ADDENDUM # 1

November 5, 2021

**Bataan Lift Station Renovation
Bid No. 2021-09**

Bohannon Huston Inc.

BHI PROJECT NO.	20210255	DWG. NO.	C-1400R	SHEET OF	16	29
-----------------	----------	----------	---------	----------	----	----

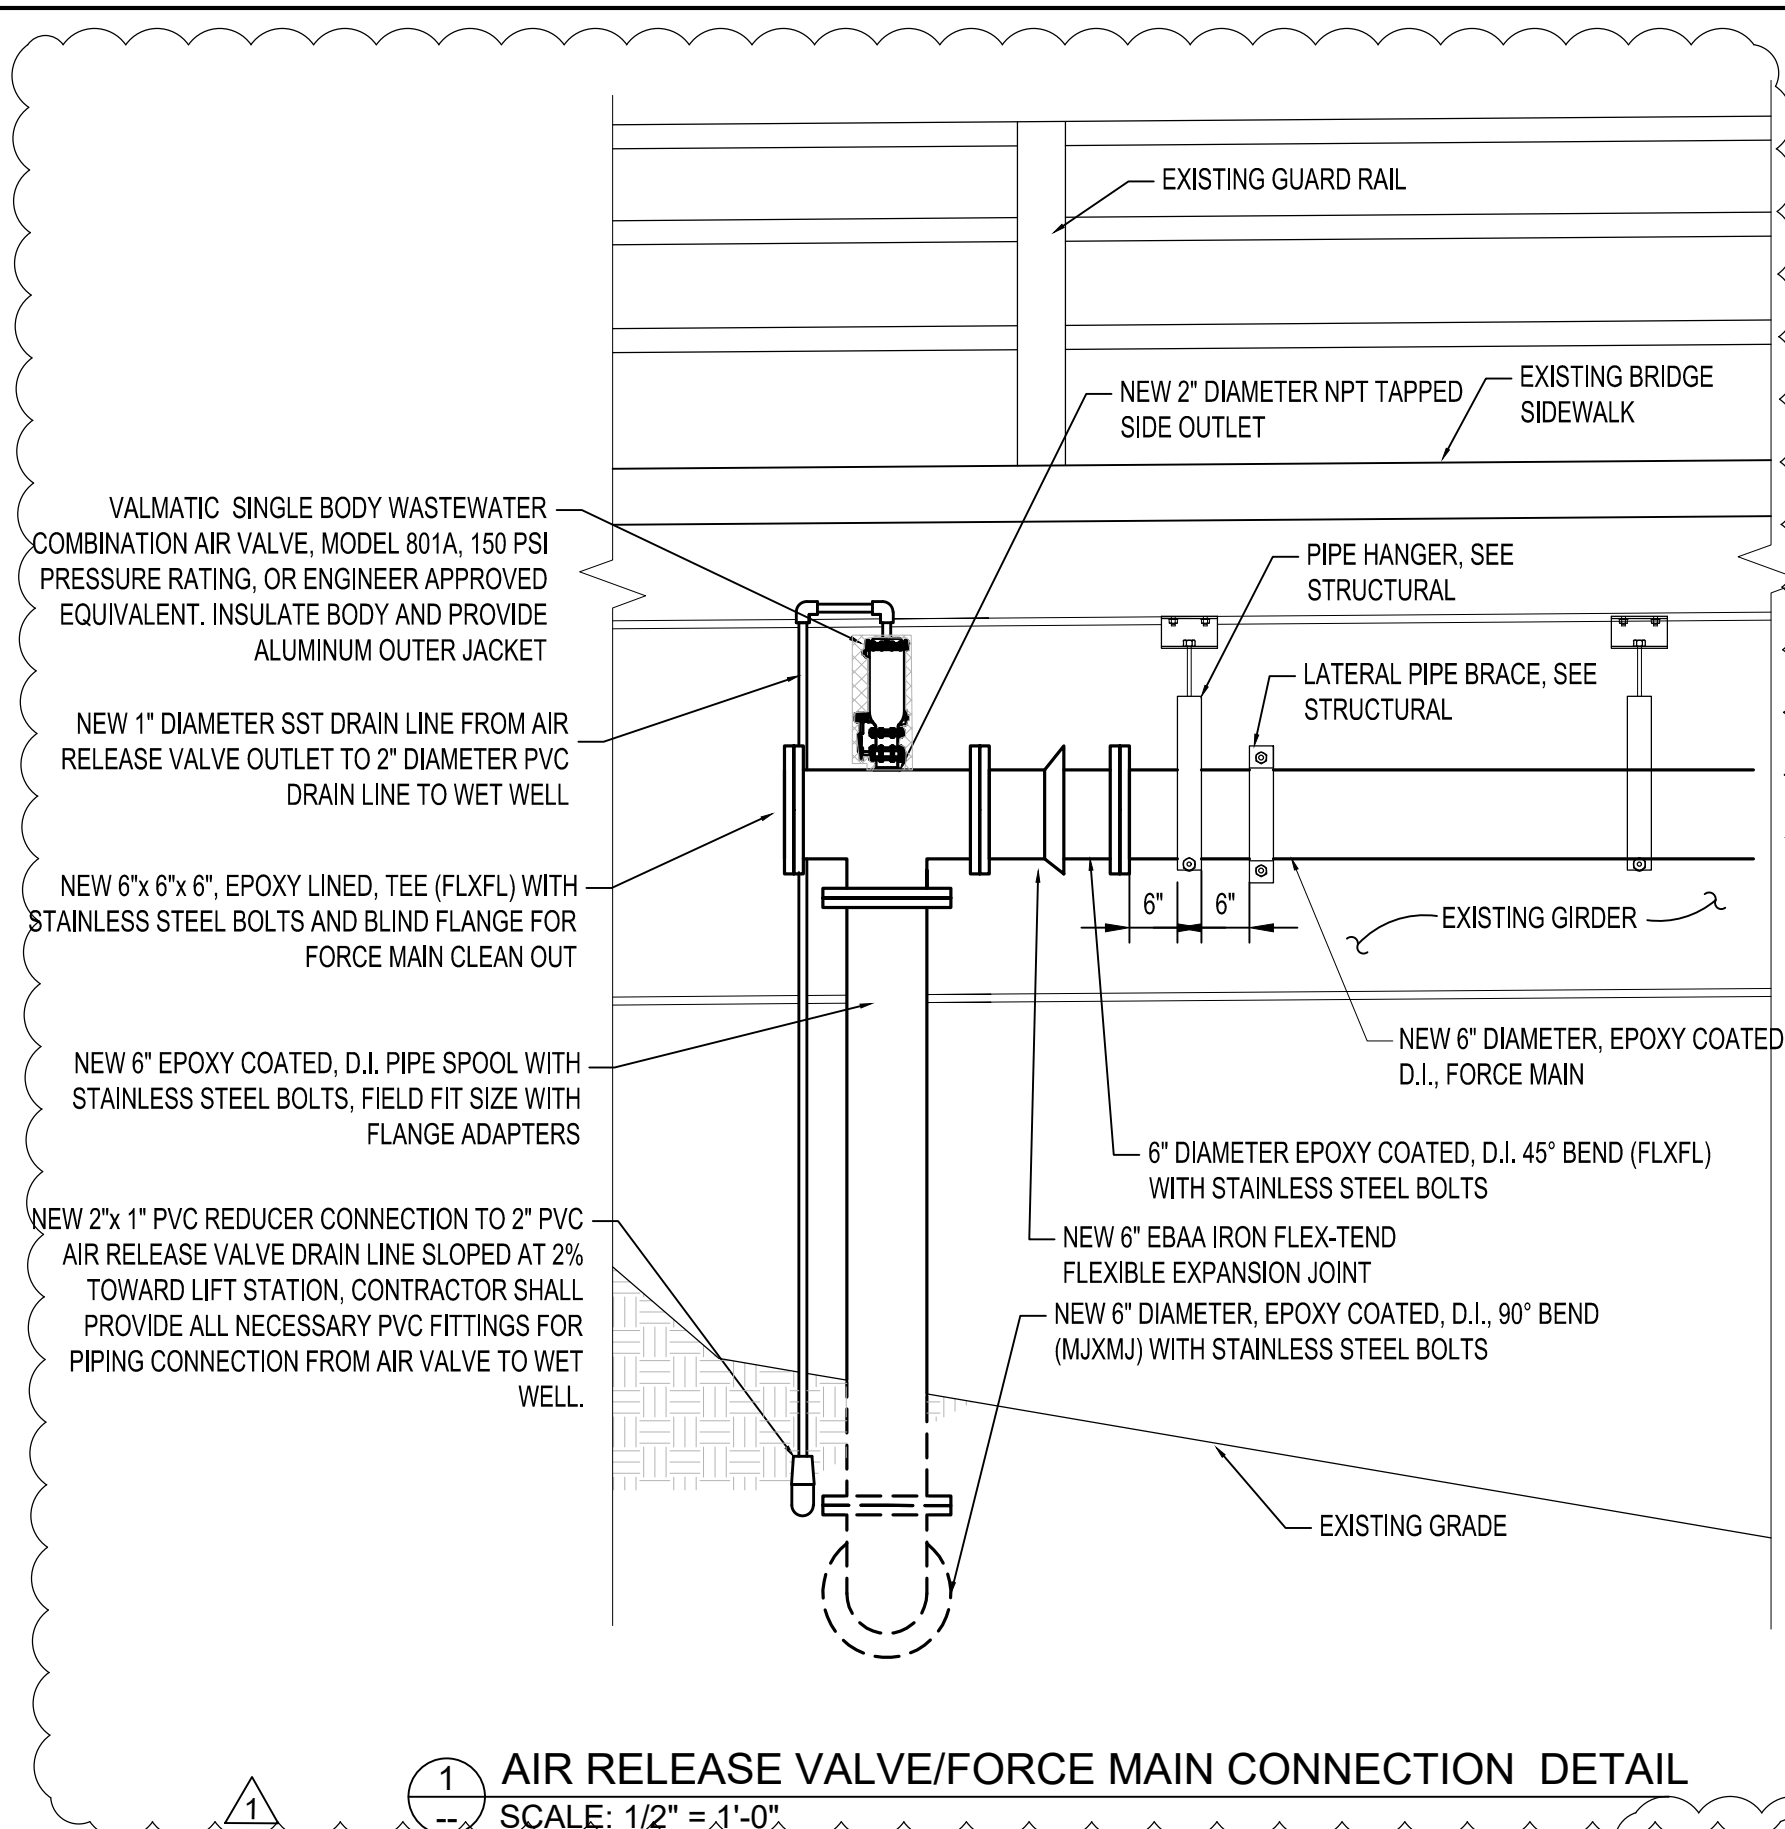
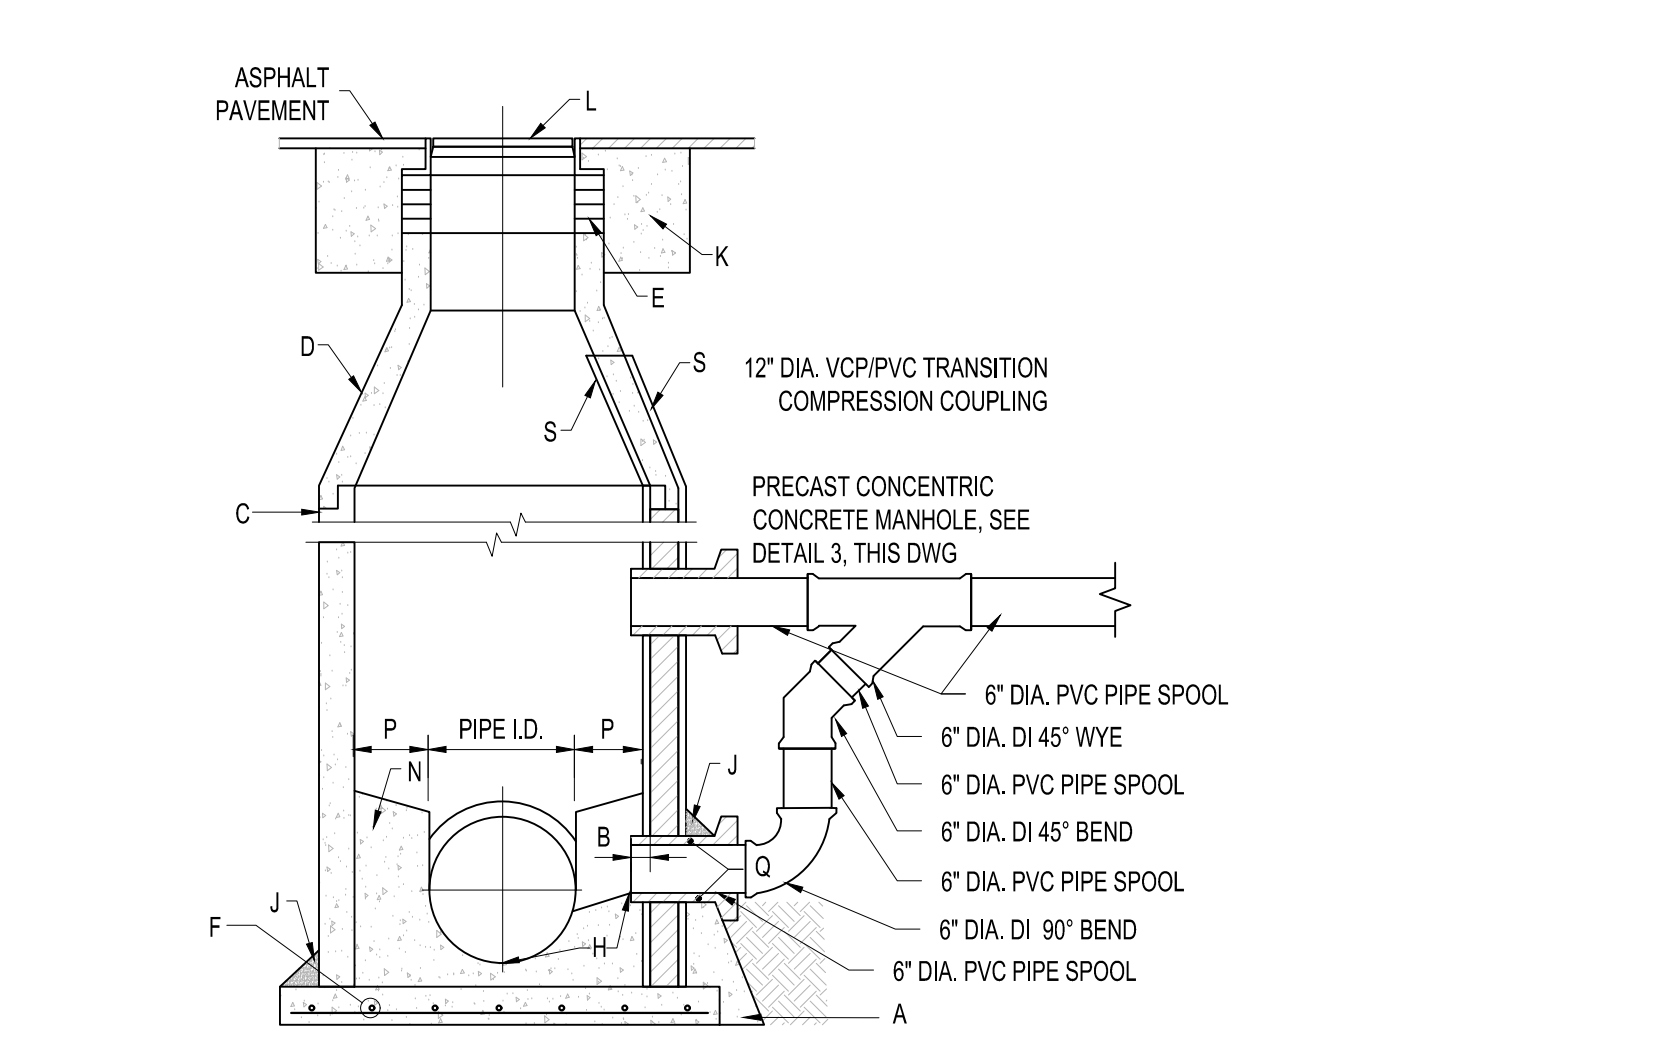
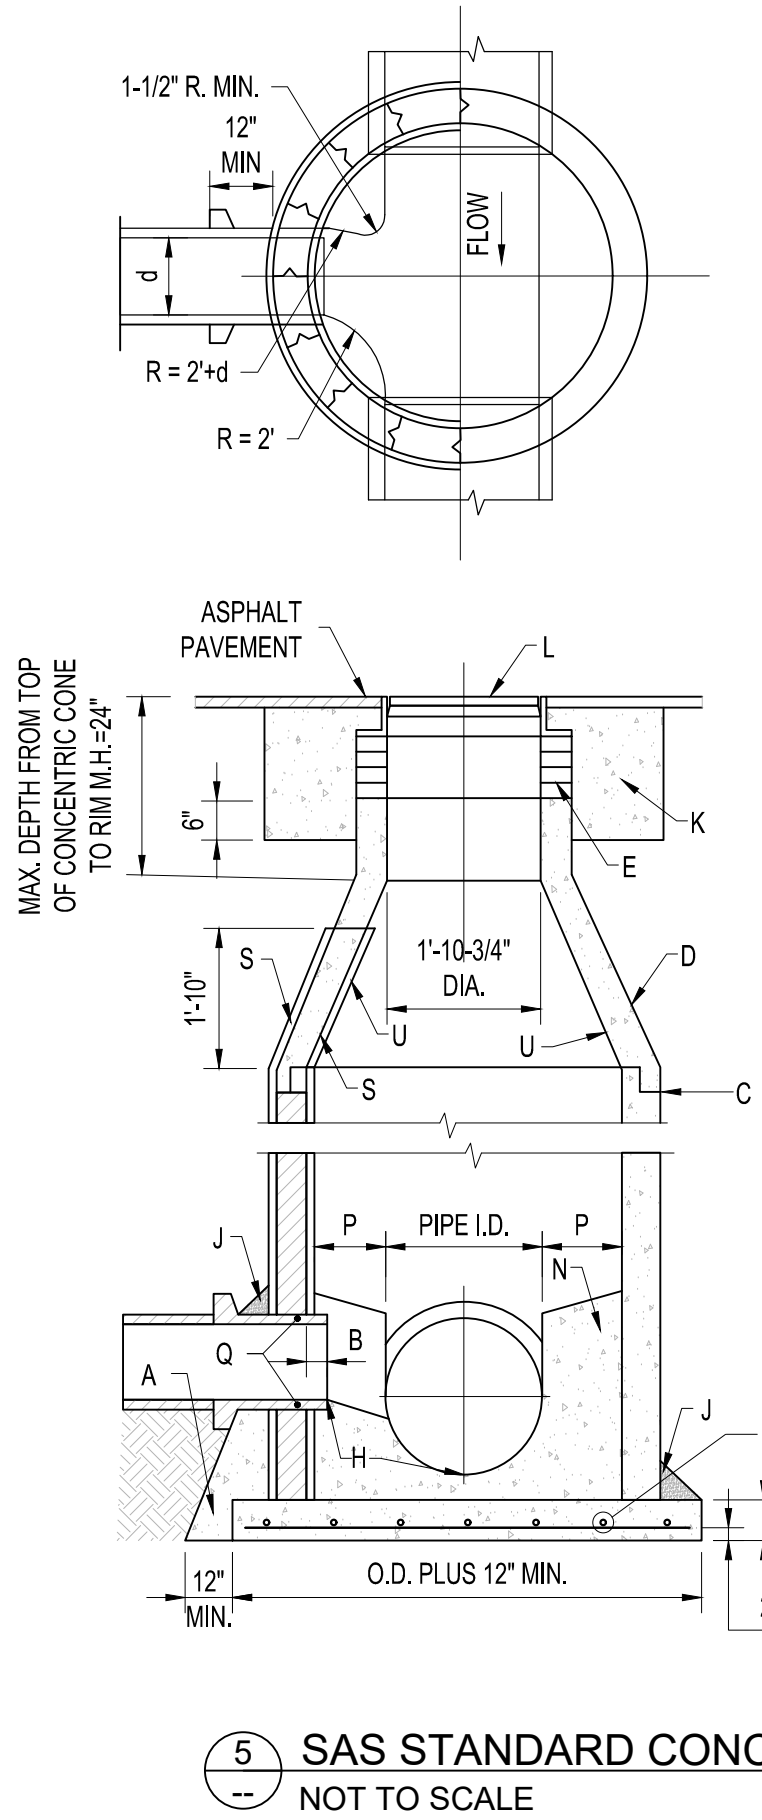
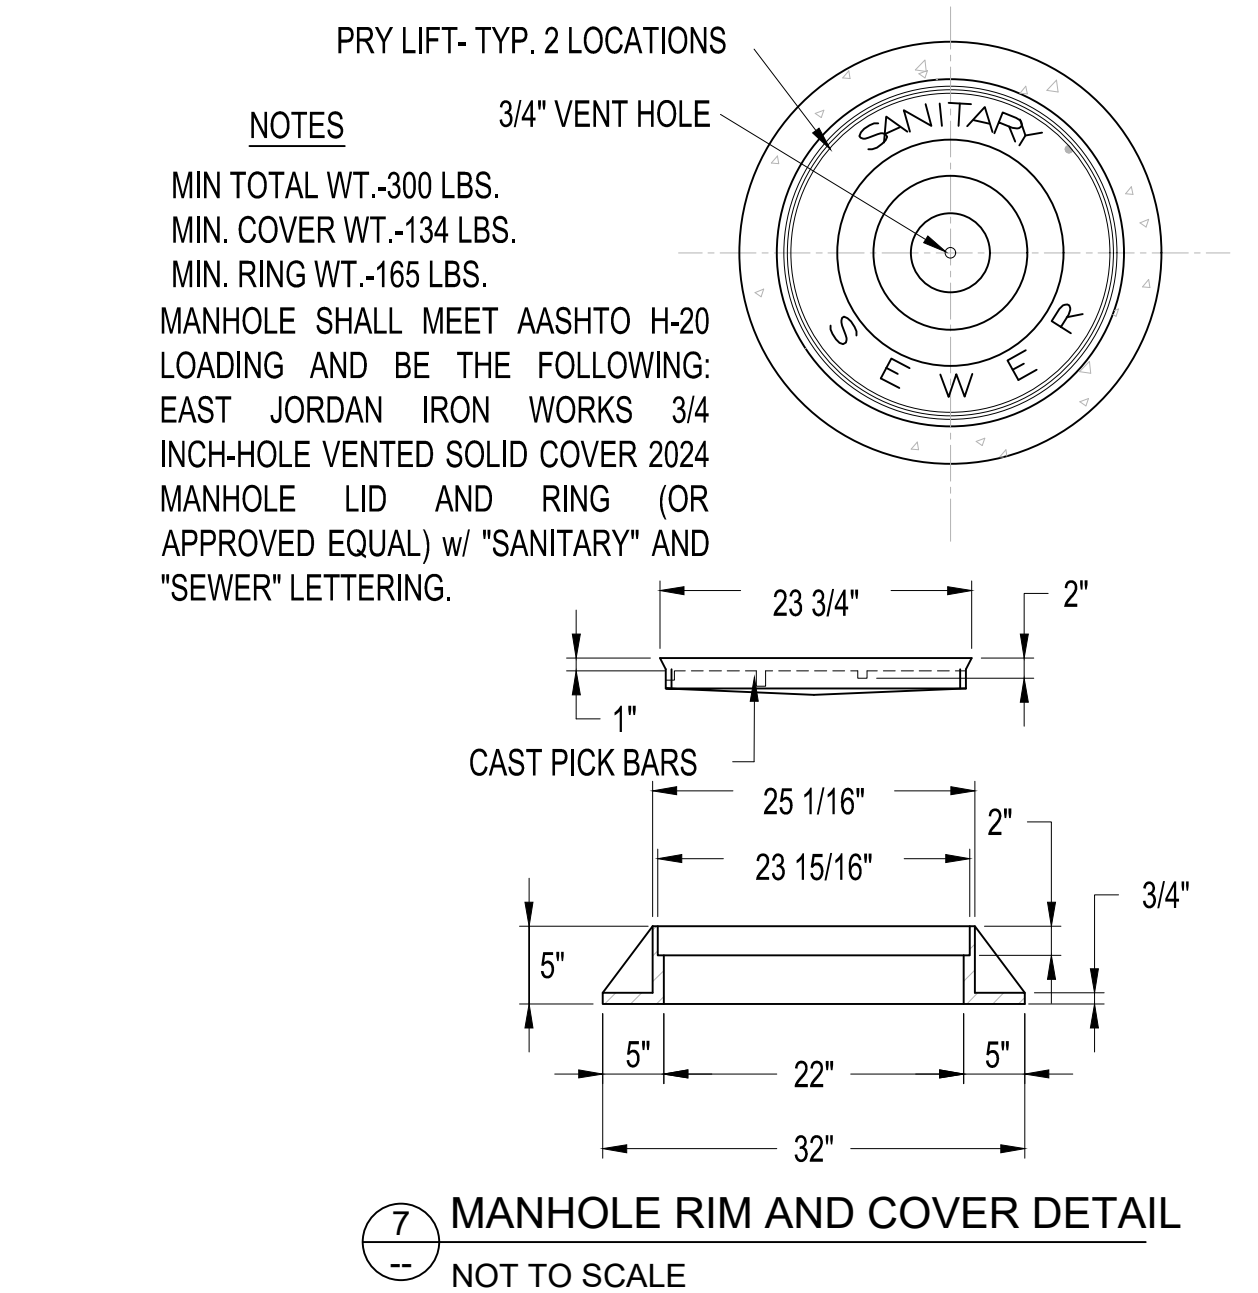
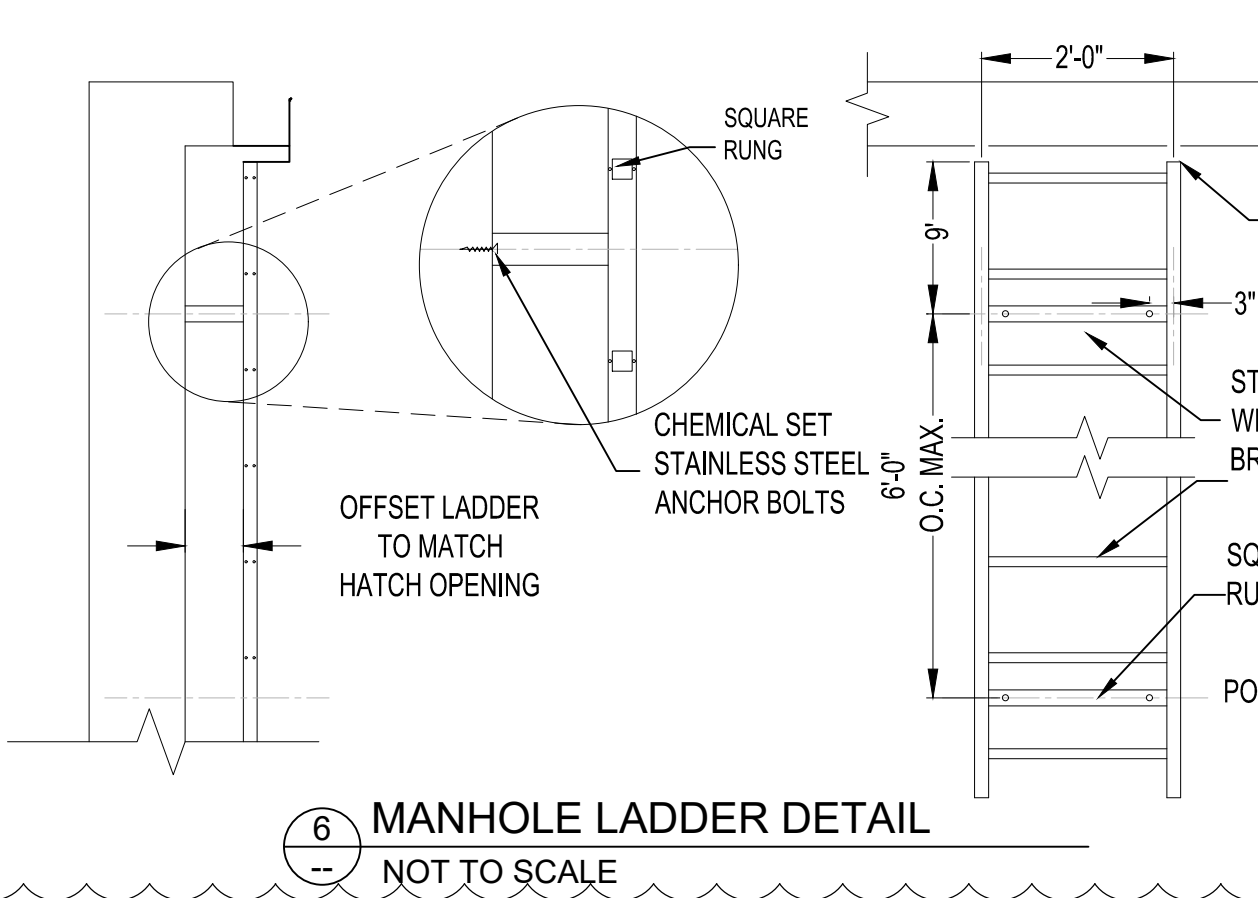
2. **Question:** Detail 7/Sheet C-1400 calls for an “OPEN GRATE” Manhole Cover. Is this correct? Will both the SD Manhole shown on sheet C-800 and the SAS shown on C-900 both be “Open Grate”?

7. **Question:** Detail 1/C-1400 calls for 10” Spool & Tee, should that be 6”?

9. **Question:** Detail 4/C-1400: Drop MH Detail, shall the related Fittings be MJ w/ P401 Lining or PVC?

4. **Drawing C-1400-R1**: Revised manhole details and force main details.
5. **Drawing E-400-R1**: Deleted submersible cable junction box and associated raised concrete pad; Moved location of pole mount light fixture adjacent to southeast corner of wet well structure; Lengthened depth of shade structure; Revised keyed note 4.

Answer: All Storm Drain and Sanitary Sewer Manhole covers shall meet AASHTO M 306-05 (OR LATEST PUBLICATION) H-20 LOADING and shall be solid 2-hole vented covers with the correct annotation across per the City of Carlsbad's standards. See revised sheet C-1400R

Answer: This has been corrected to show a new 6” spool & 6” x 6” x 6”

epoxy lined tee with stainless steel bolts. See C-1400R for revisions.

Answer: All Ductile Iron Fittings on the drop manhole are to be Protecto 401 epoxy lined (or approved equivalent) and have EBAA Iron mechanical restraints.
